SUBJECT: Change of 0201 MLCC (ECJ-ZExxxxxxx) Packaging Specification

BULLETIN #: ECN.PG33.03.17.06-1

Date: March 20, 2006

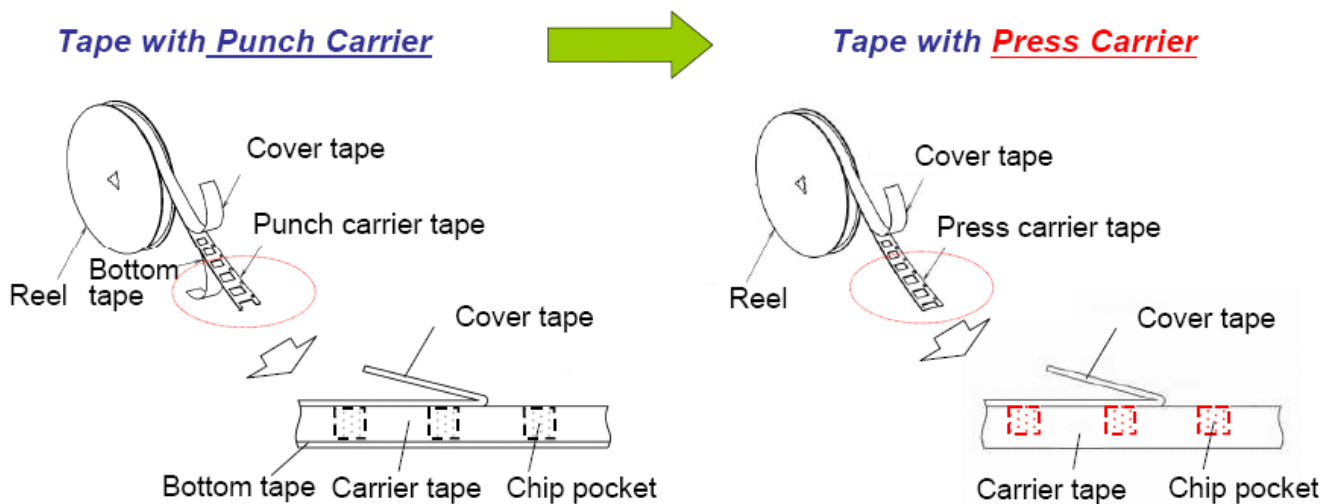
ENGINEERING CHANGE DETAILS: Punch Carrier tape to Press Carrier tape

REASON FOR CHANGE: To improve the 'picking' of 0201 parts from their taped reels and its mounting performance

2 main improvements:

- Reduces the occurrences of 'standing' or 'non pick-up' components due to the components sticking to the bottom tape
- The shape of the component 'pocket' is more consistent with regard to its dimensions and component clearances
